**MONITORING YEAR 0
ANNUAL REPORT
FINAL**

BUG HEADWATERS MITIGATION SITE

Subject: Draft MY0 Report Review
Bug Headwaters Mitigation Site, Wilkes County
Yadkin River Basin: 03040101
DMS Project ID No. 100084
DEQ Contract #. 7617

Figure 1b. Current Condition Plan View
 Bug Headwaters Mitigation Site
 Yadkin Basin 03040101
 Monitoring Year 0 - 2021

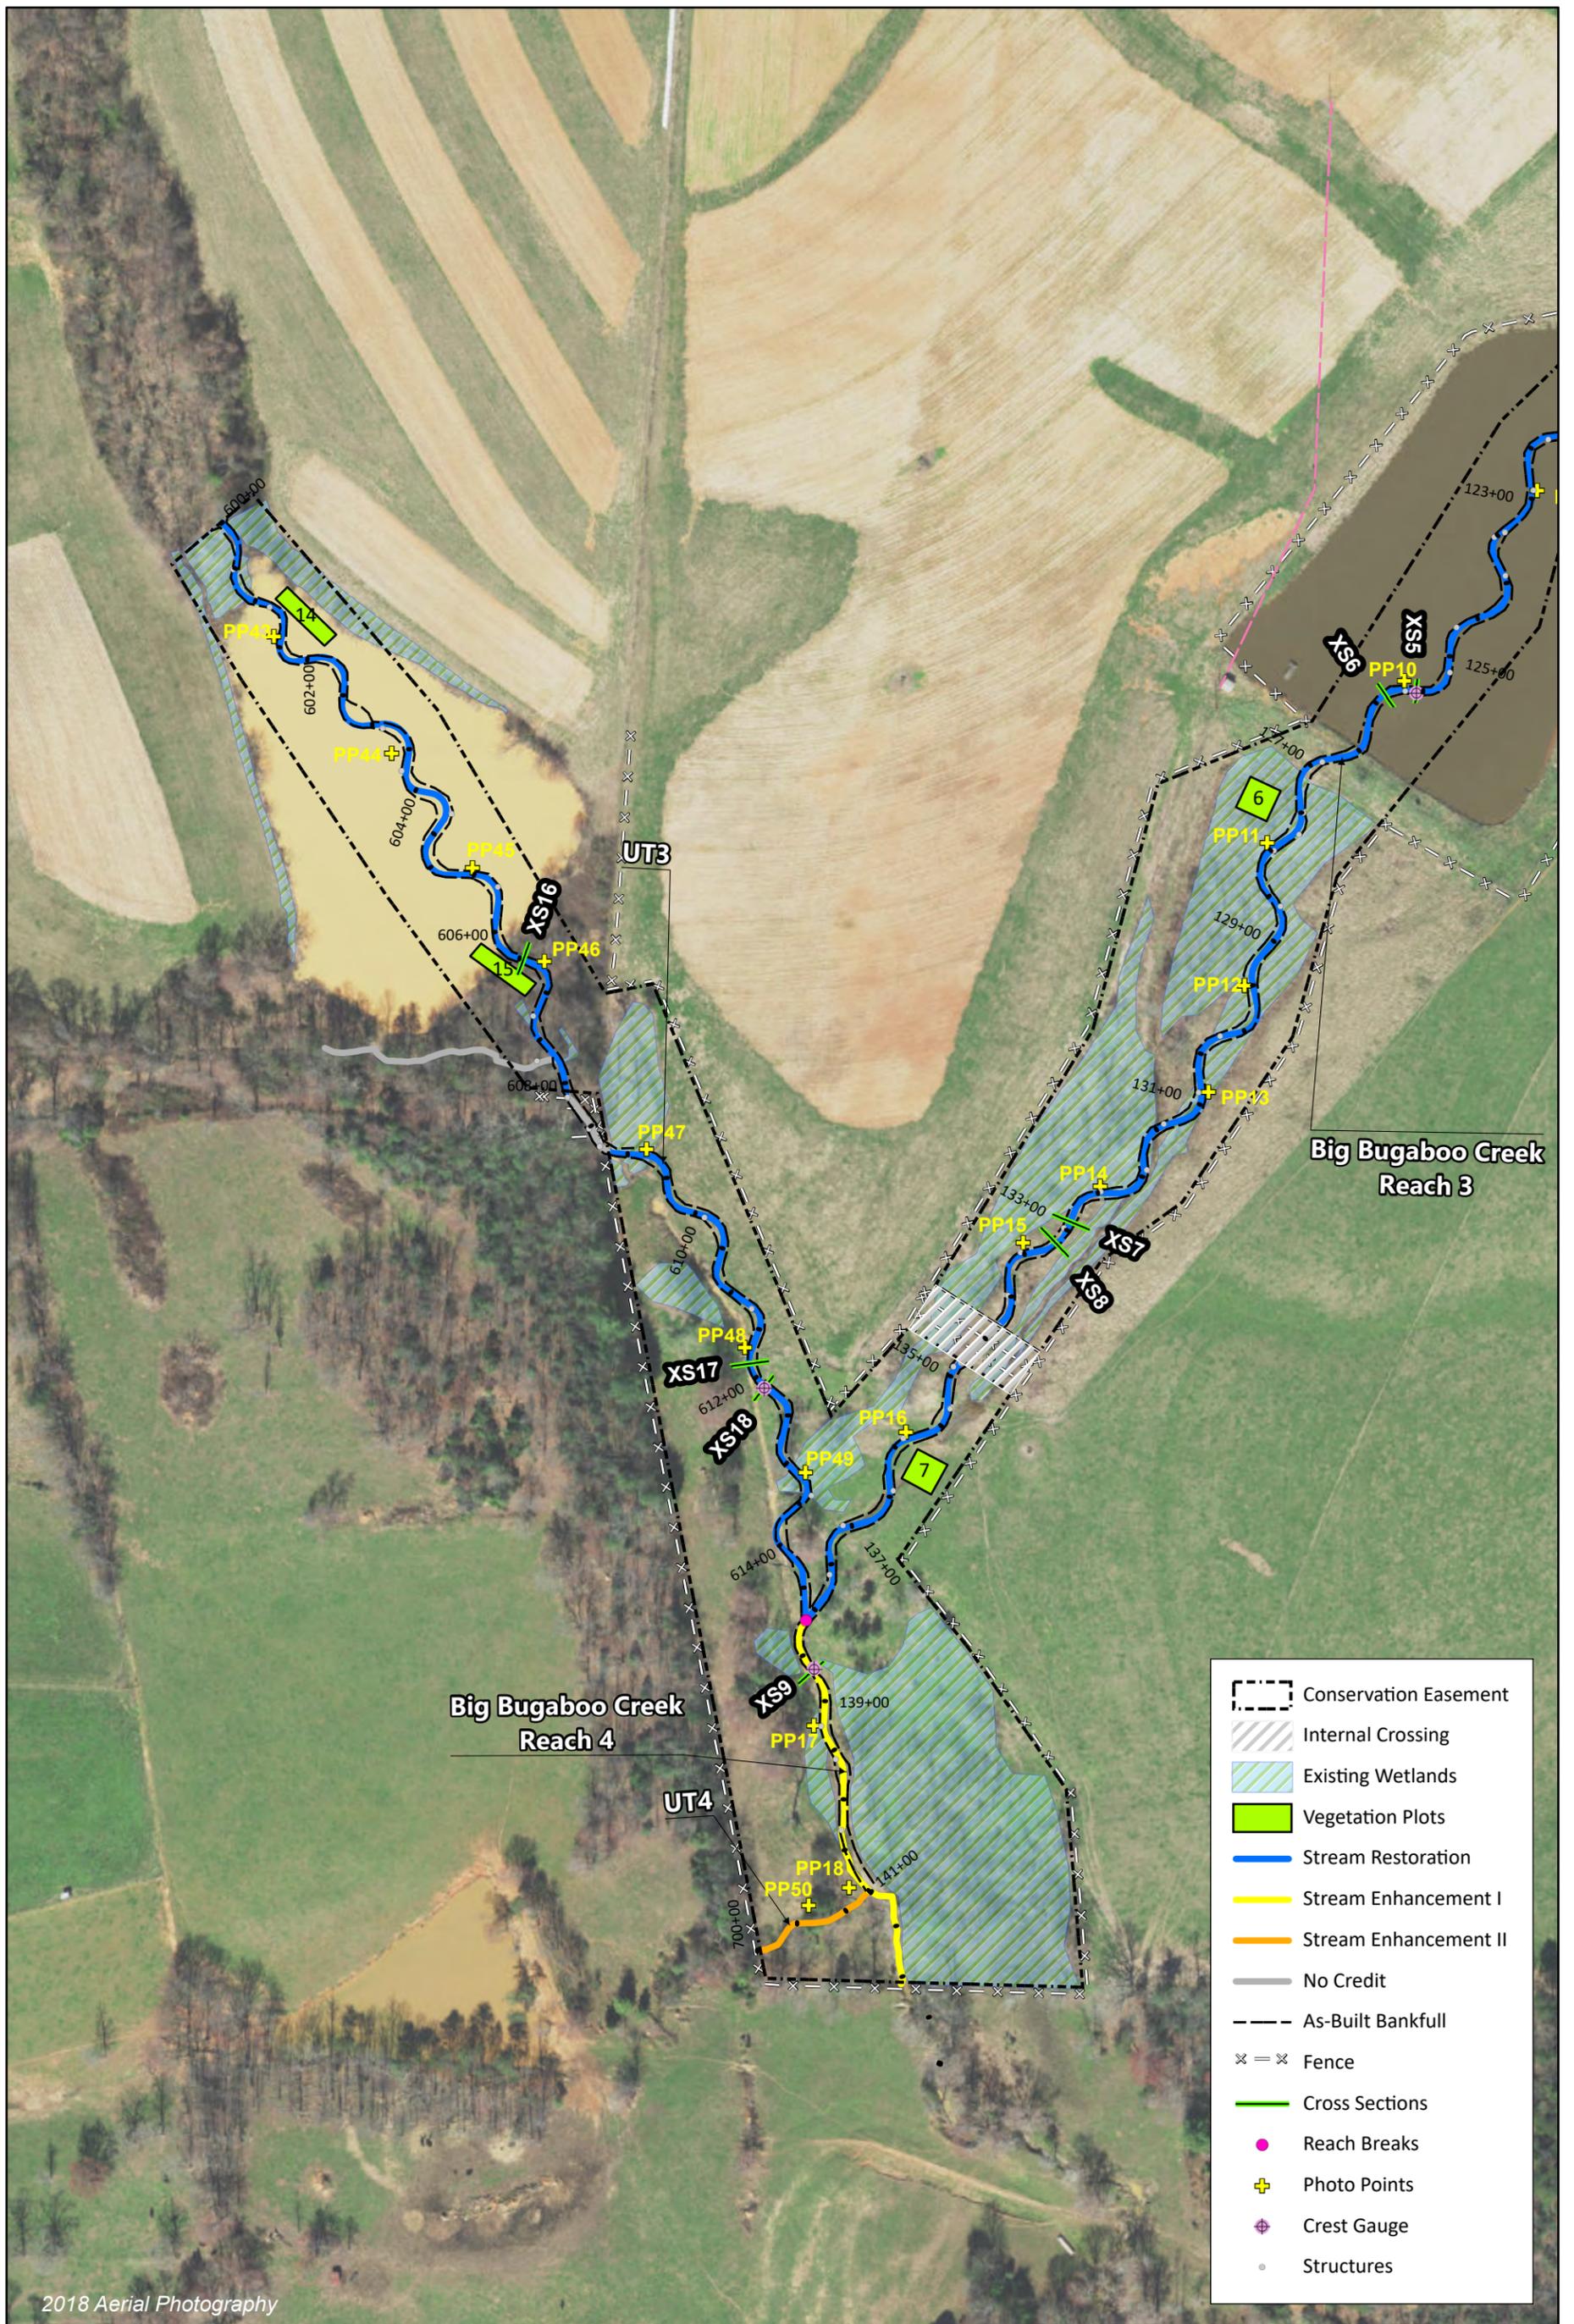
CCPV: UT3 alignment should be shown as constructed on the CCPV. It is currently shown in the design location prior to the realignment. This deviation is captured correctly in the asbuilt/redline drawing, but is not necessary for the CCPV.

Response: The UT3 realignment is now shown in the CCPV and in the digital files as "Design_Centerlines_Final".

1.12

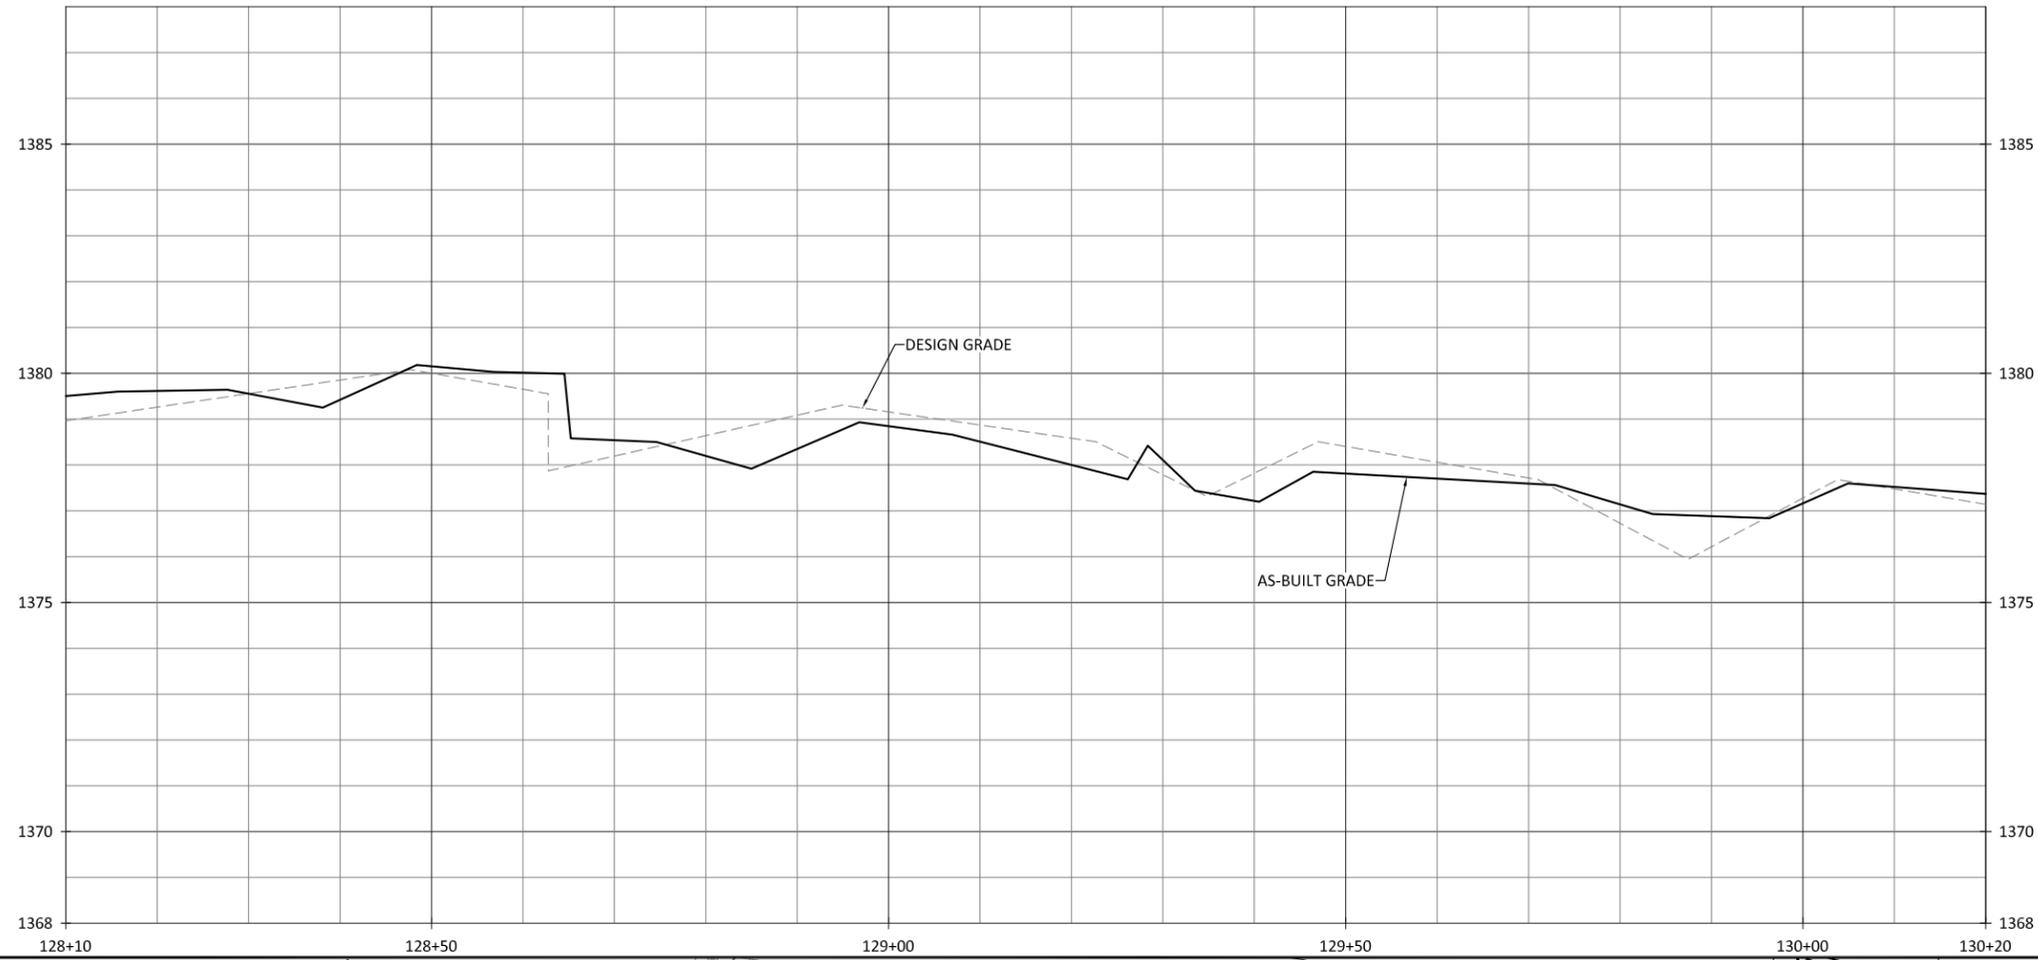
Sheet 1.12: Revise note #2 for final.

Response: Note #2 has been removed.

1.17

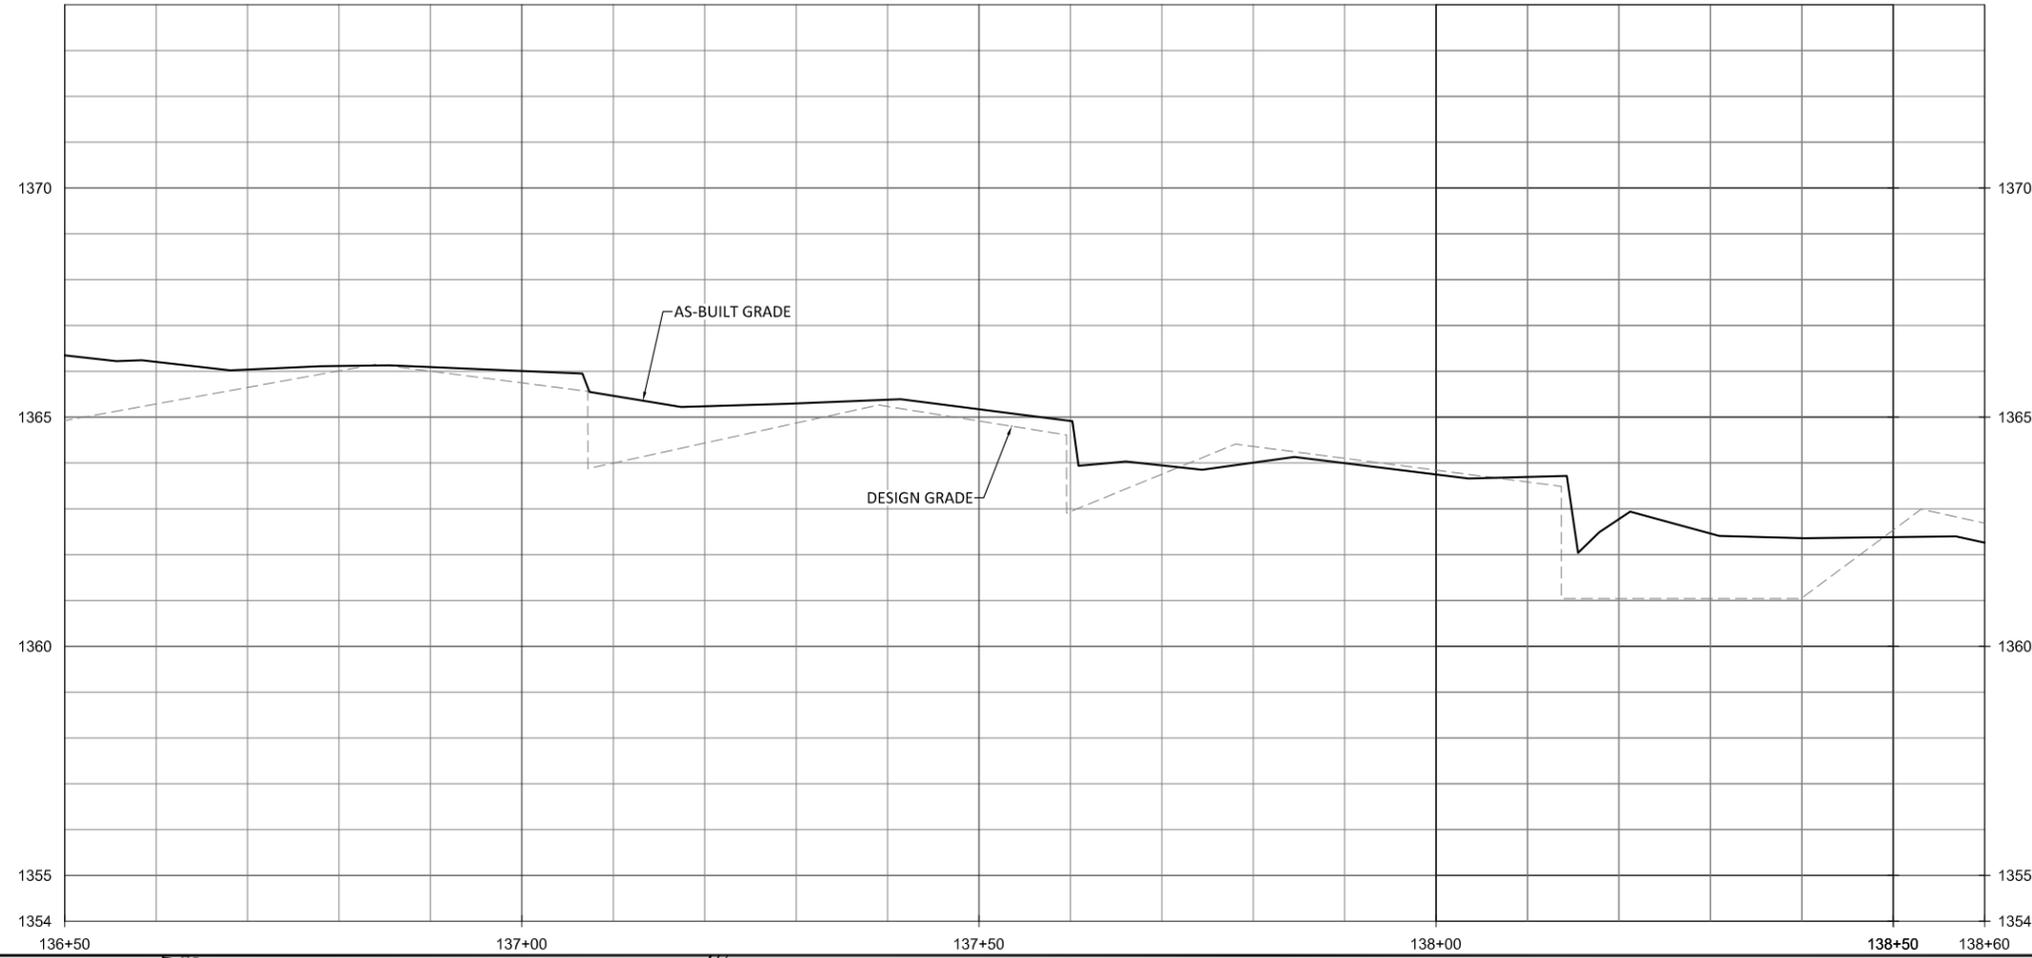
Sheet 1.17 and 1.18: Symbol for "asbuilt culvert" is shown on each sheet. Please revise or explain.

Response: The two "as-built culvert" symbols have been removed.
